**PLANS AND DOCUMENTS
referred to in the PDA
DEVELOPMENT APPROVAL**

Approval no: DEV2024/1566

Our Ref: 24GCT0144_LT03

RE: 9 Hercules Street, Hamilton – Traffic Engineering RFI Response

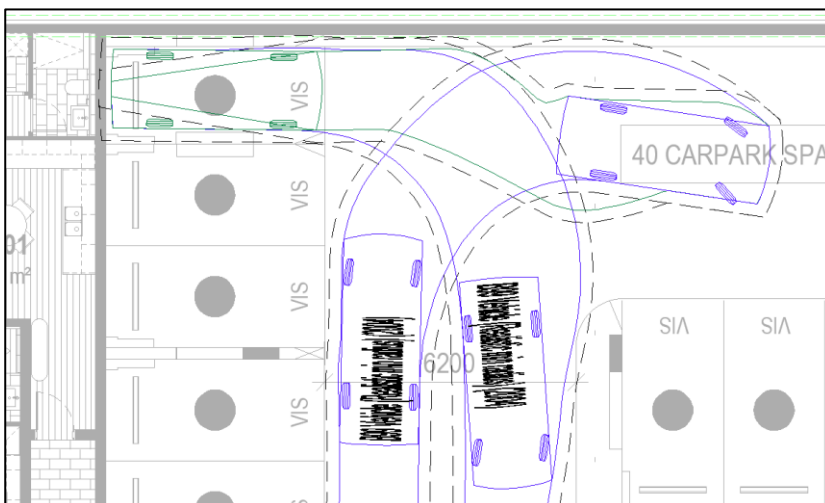
a) Level 1-3 podium level plan, parking bay 8 (2.4m wide) is stated as a visitor bay. The proposed 2.4m wide visitor bay does not comply with AS2890.1.

It is recognised that 2.4m wide visitor bays do not comply with AS2890.1 class 2 spaces however the bay is located in a position that allows for simplified access and egress, compared to mid-block spaces, and it maintains 300mm clearance to the adjacent wall.

As shown in the image above, the space is suitably accessible by B99 vehicles without encroaching or impacting on the adjacent space. The minor reduction still retains a standard sized space, which is preferred over reverting to a small car space.

The provisions of visitor bay 8, has been reviewed by the undersigned Registered Professional Engineer of Queensland and is deemed to be appropriate, fit for purpose and are not considered to impact on the safety or operation of the site or users.

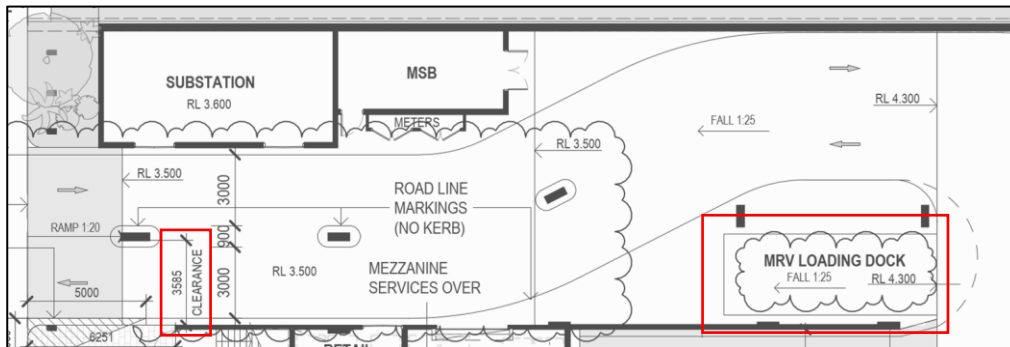
Provide amended plans that illustrate the proposed MRV parking bay to be maximum 4% slope (1:25) in accordance with TAPS PSP.

The development plans have been annotated to show the maximum slope of the loading dock is 1:25 as per TAPS PSP requirements. Refer to the updated plans for details.
